LETTER AND RESPONSE TO REGULATOR COMMENTS ON FOURTH FIVE-YEAR REVIEW
REPORT NIROP FRIDLEY MN (PUBLIC DOCUMENT)
9/27/2013
TETRA TECH

Subject: Responses to Comments - Fourth Five-Year Review Report
NIROP Fridley, Fridley, Minnesota

**RESPONSES TO EPA COMMENTS ON THE FOURTH FIVE-YEAR REVIEW
REPORT
DATED MAY 2013**

**NAVAL INDUSTRIAL RESERVE ORDNANCE PLANT
FRIDLEY, MINNESOTA**

EXHIBIT 2
DESIGNATED RESTRICTED AREAS
NAVAL INDUSTRIAL RESERVE
ORDNANCE PLANT
FRIDLEY, MINNESOTA

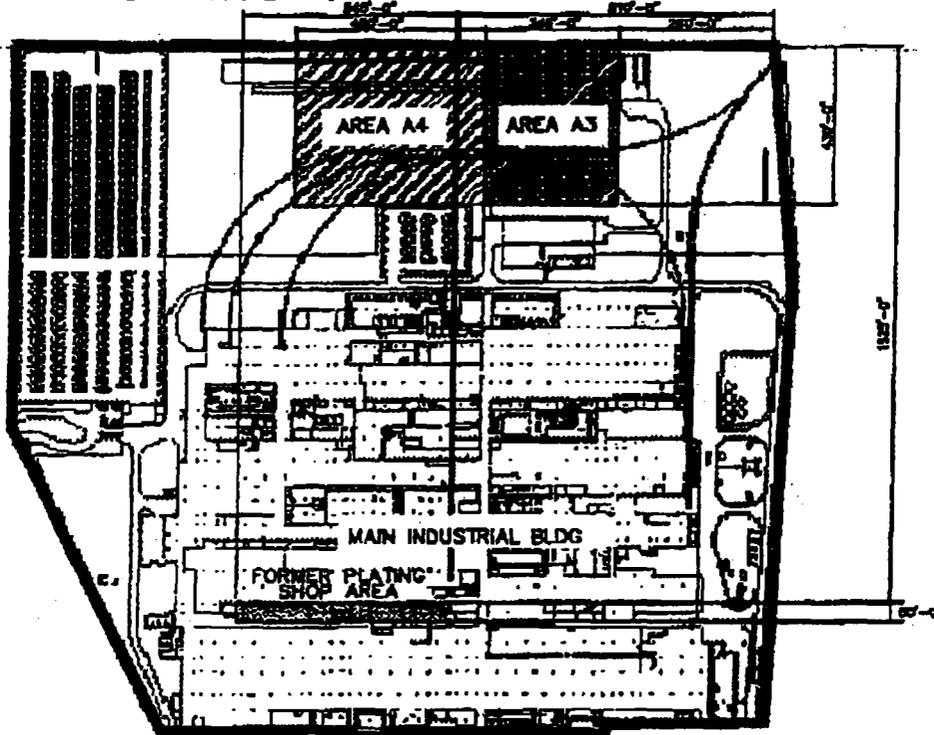
10. Comment: The Fourth 5YRR does not include a figure showing the locations where land use controls (LUCs) apply (i.e., Designated Restricted Areas, North 40, or Former Plating Shop). While Figure 3-1 (Site Plan) and Attachment 3 (TCE Isoconcentrations Maps and Approximate Capture Zone Configurations) figures indicate where OU2, OU3 and the approximate location of the East Plating Shop (i.e., Former Plating Shop) are located, a figure showing the specific locations where LUCs apply is not included. Revise the Fourth 5YRR to include a figure showing the specific locations where LUCs apply.

Response: The Five-Year Review does contain this information; it is located in Attachment 2, following the Site Inspection Checklist.

TCE ISOCONCENTRATION MAPS AND APPROXIMATE CAPTURE ZONE CONFIGURATIONS

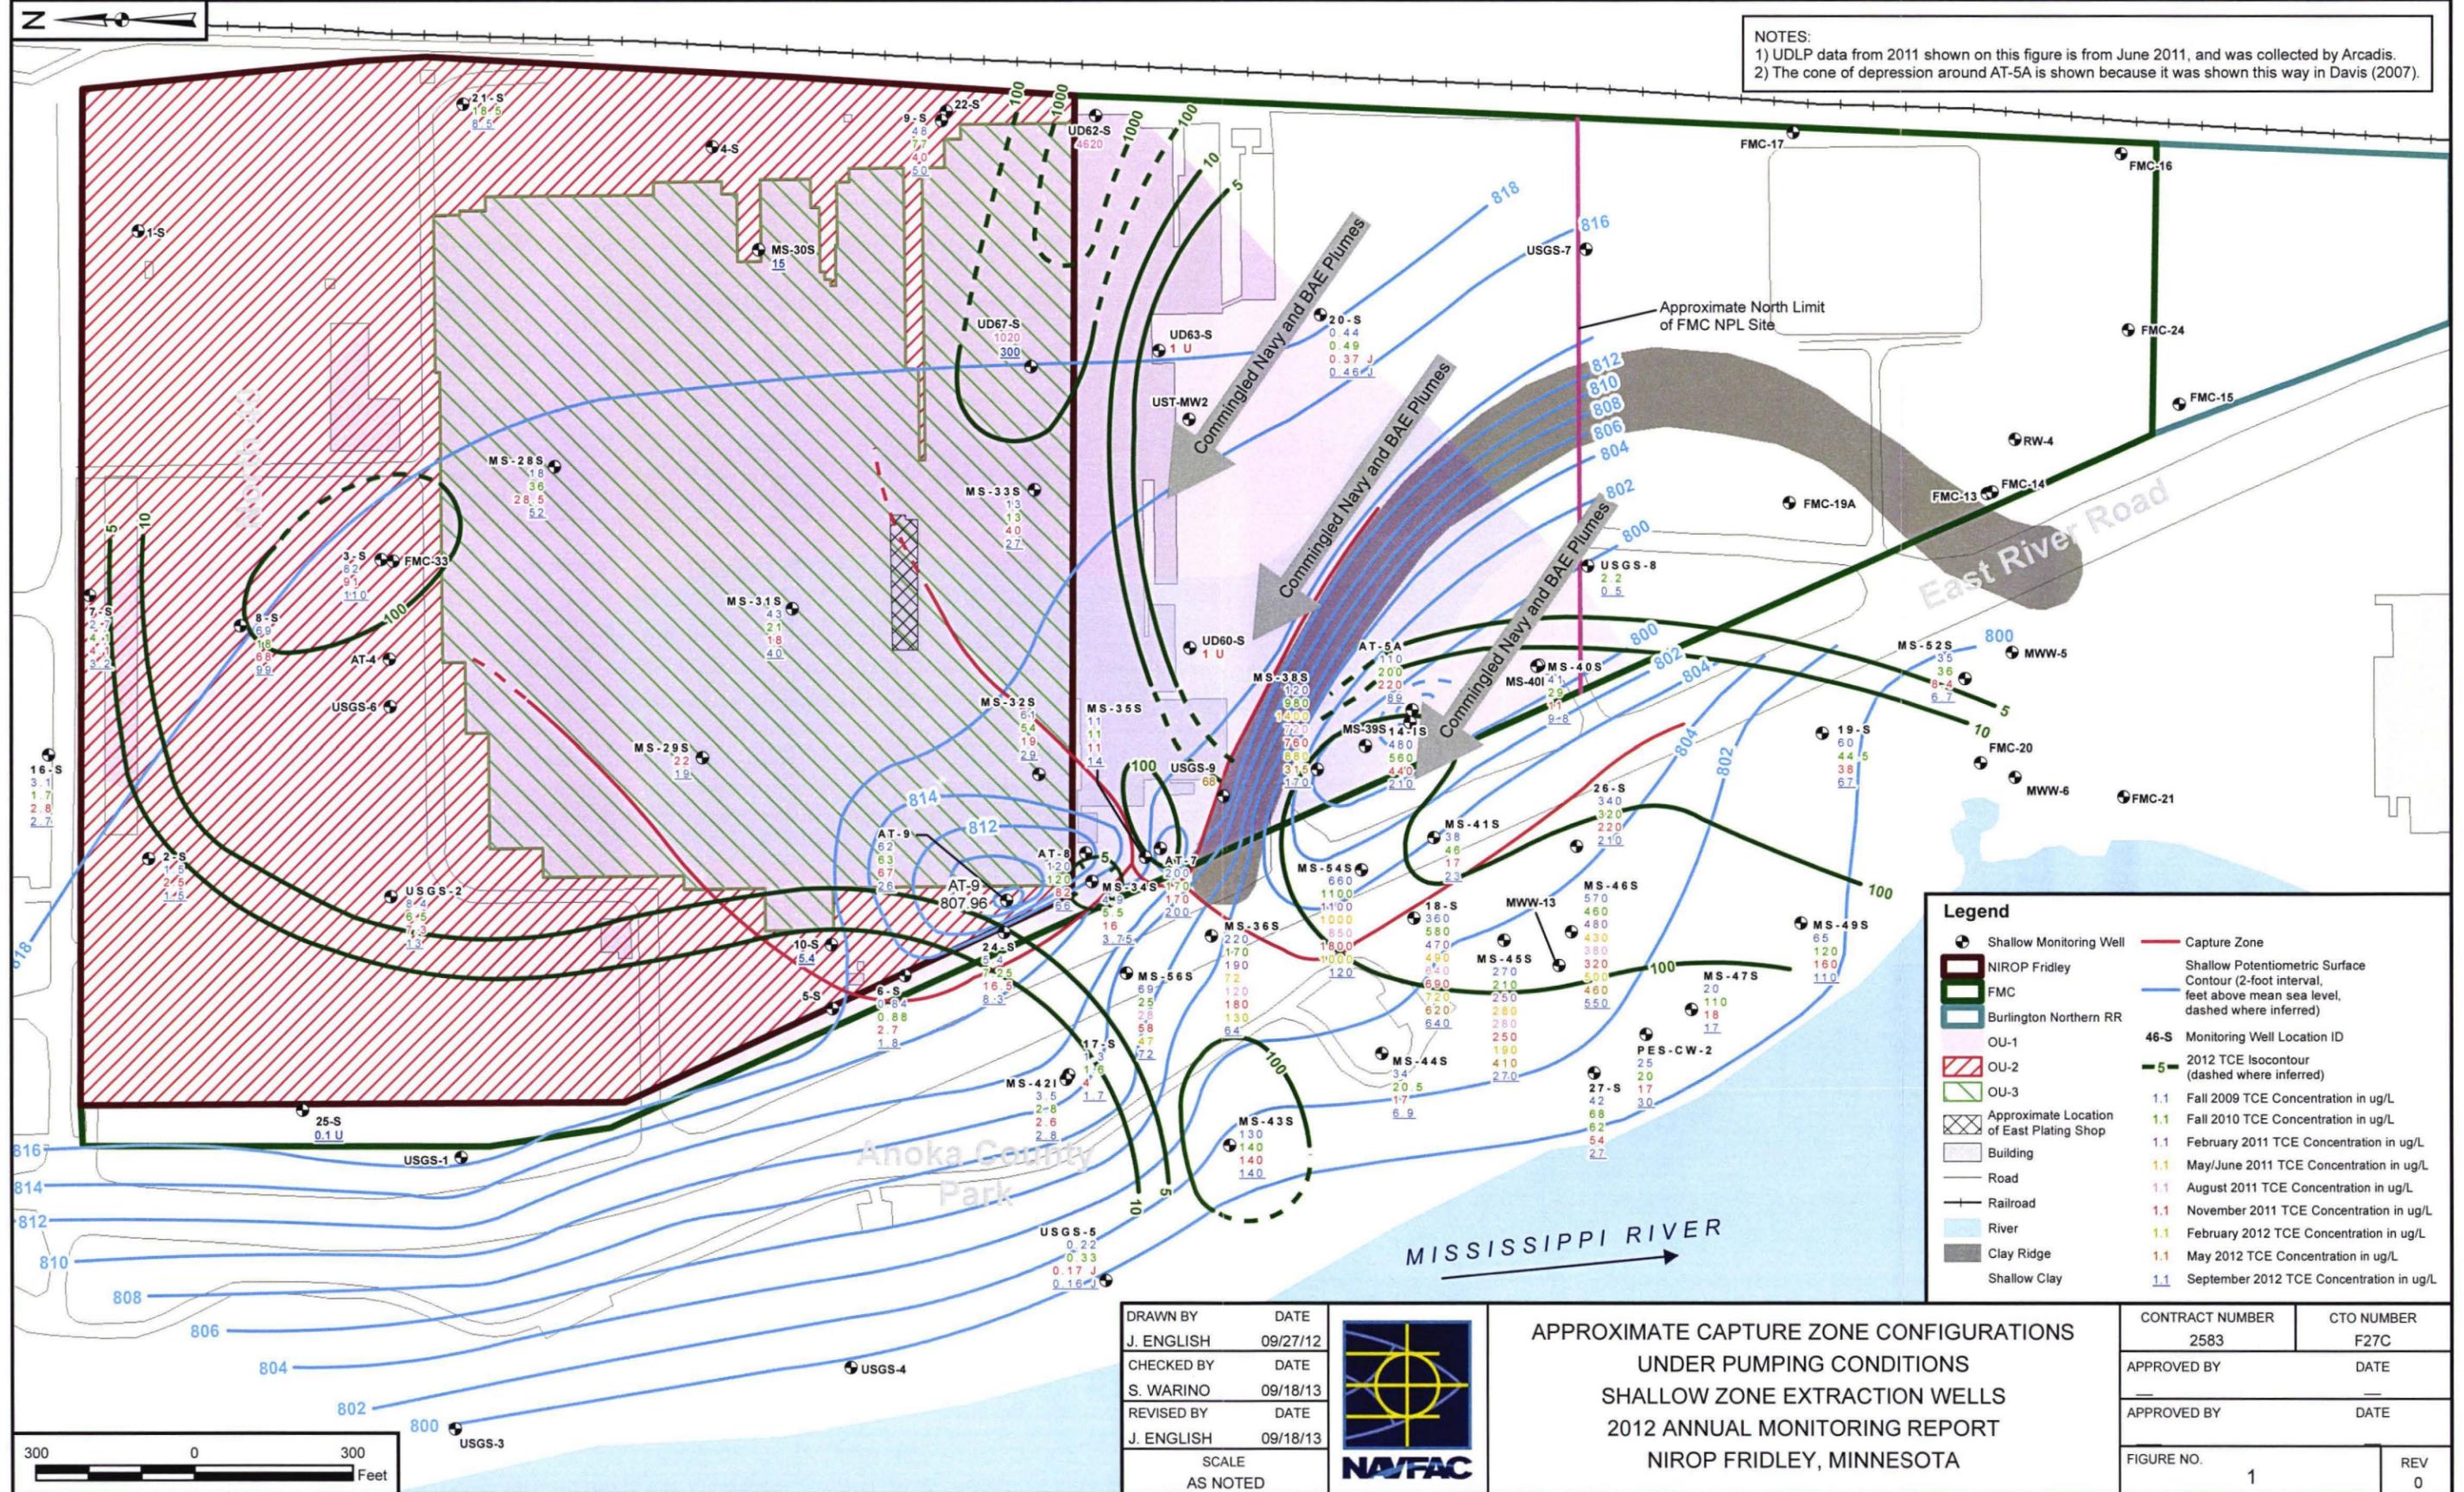
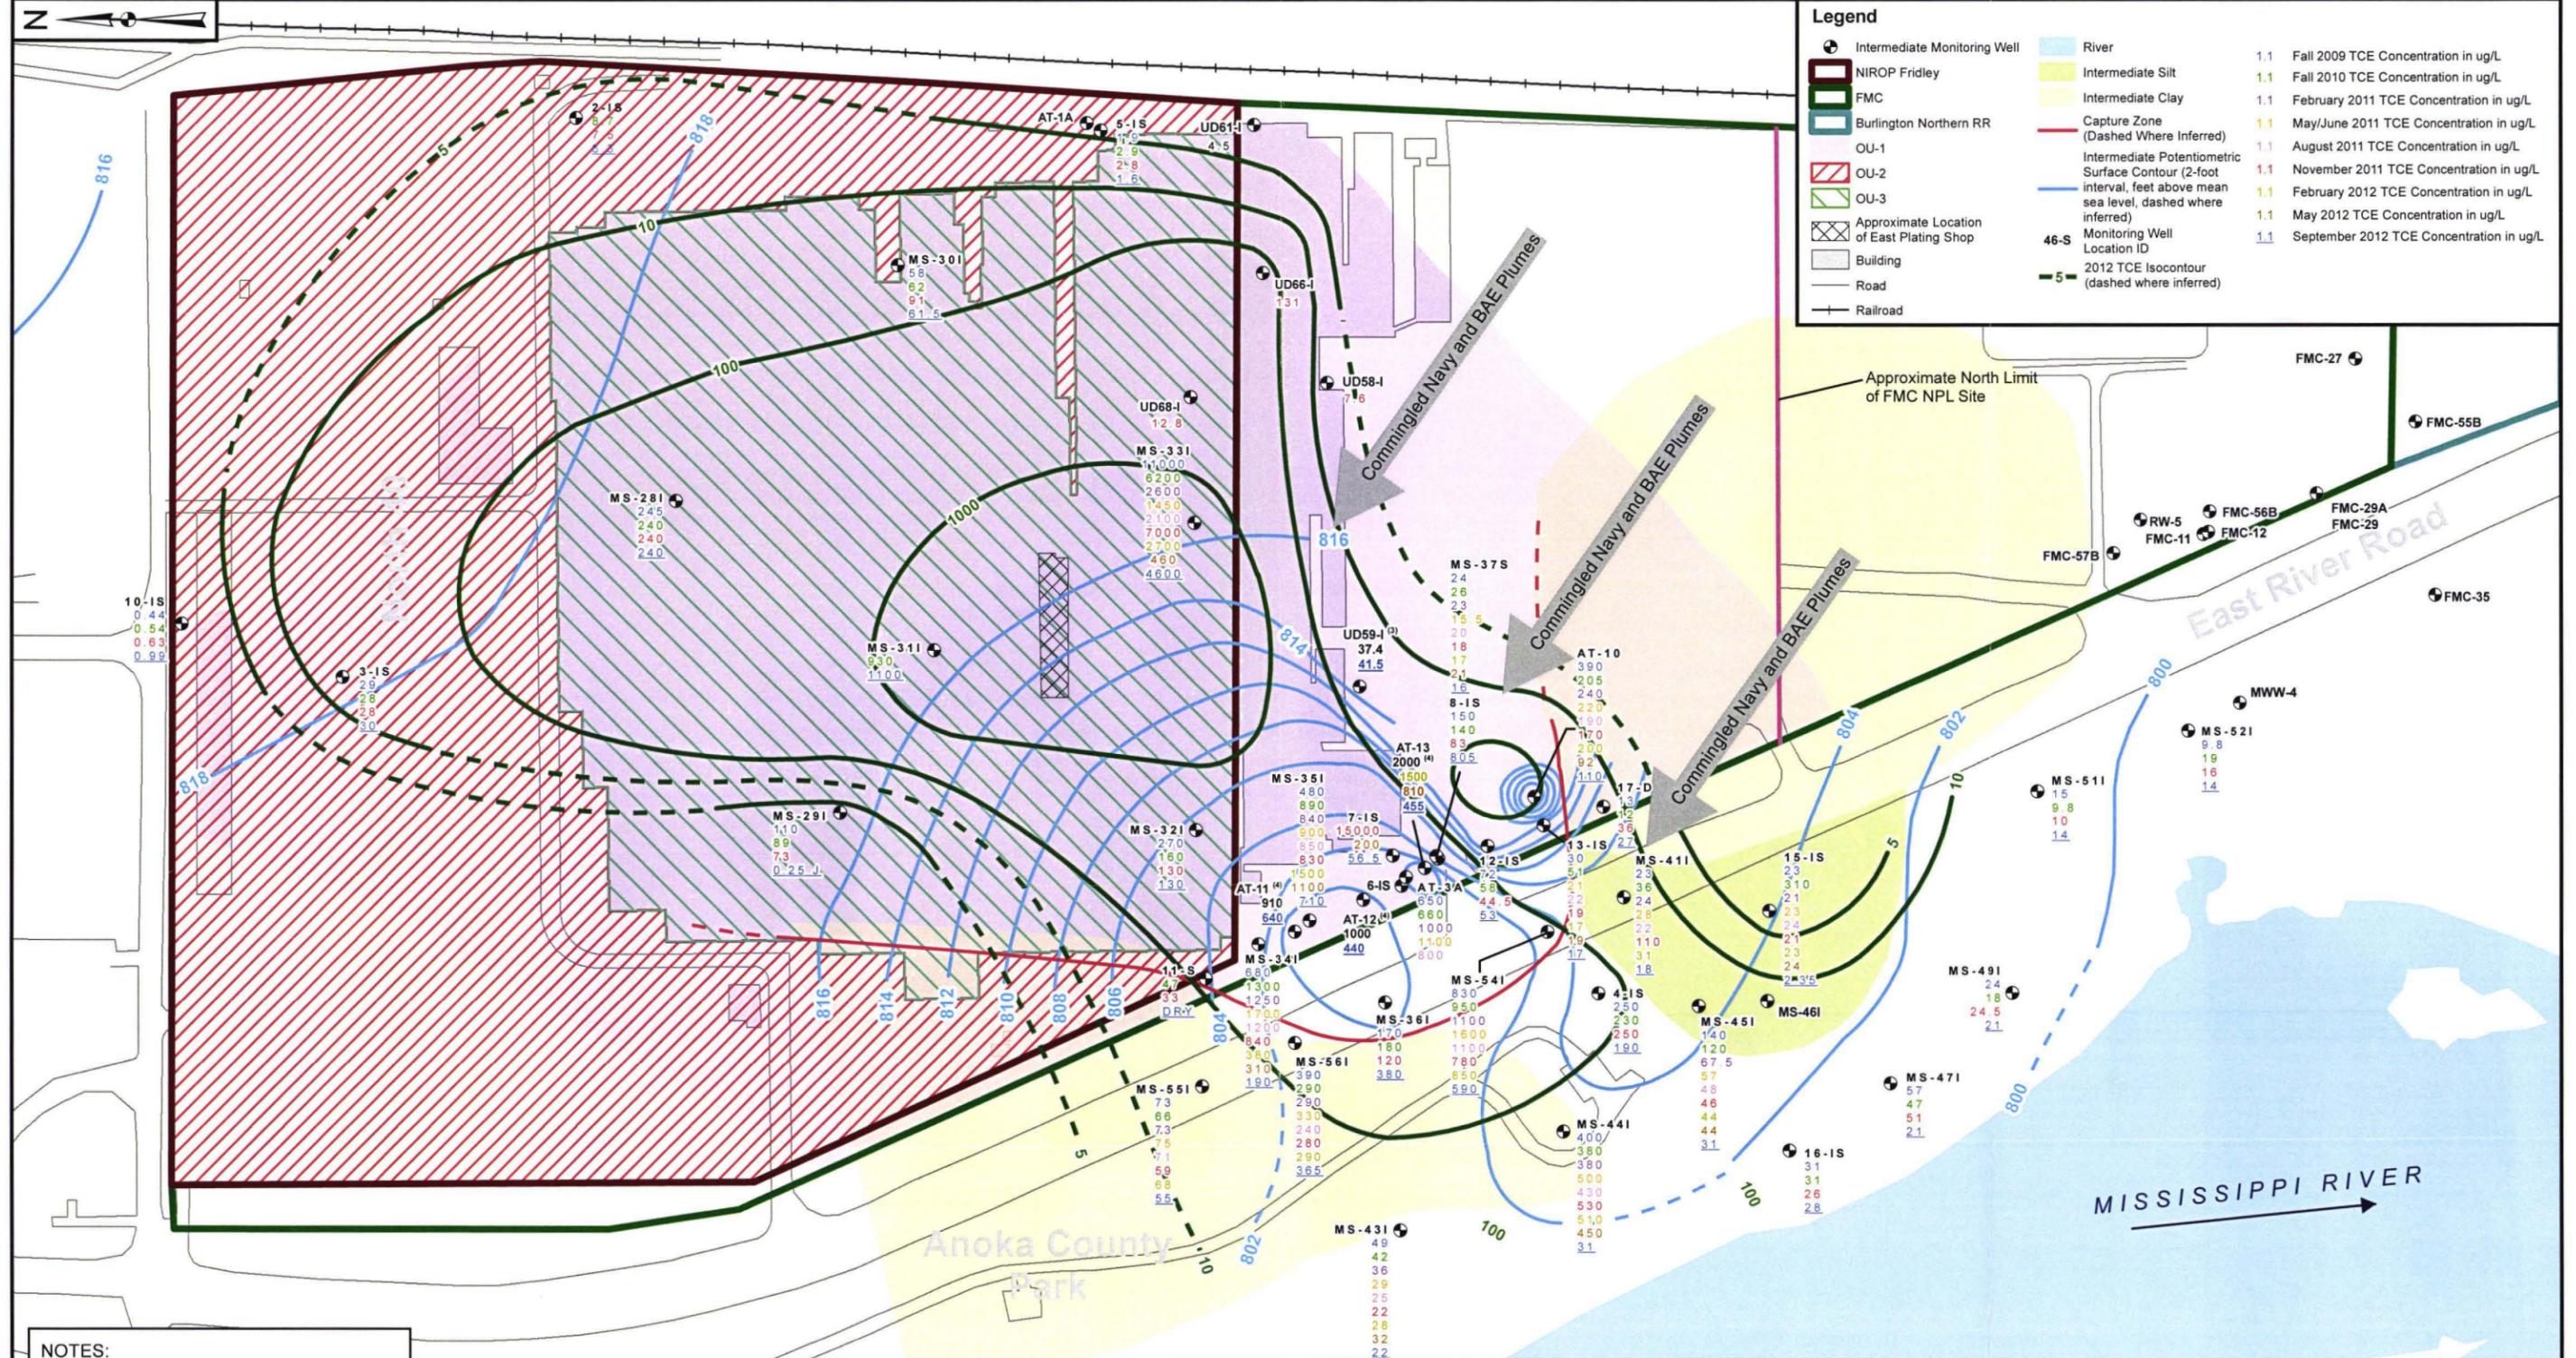
12. Comment: Section 7.2.5.1, Problem B: Effectiveness of the Capture Well System, Page 7 of 9: The last sentence of Section 7.2.5.1 references Attachment 3 as support that the system continues to show significant improved performance; however, Attachment 3 (TCE Isoconcentration Maps and Approximate Capture Zone Configurations) includes TCE isoconcentration maps and the approximate capture zone configurations. These do not show significant improved performance of the system. Revise Section 7.2.5.1 to reference figures and tables which support that the system continues to show significant improved performance.

Response: The following text has been added just before the reference to Attachment 3: “and effectiveness in capturing contaminated groundwater”. The figures are meant to show substantial capture of contaminated groundwater.
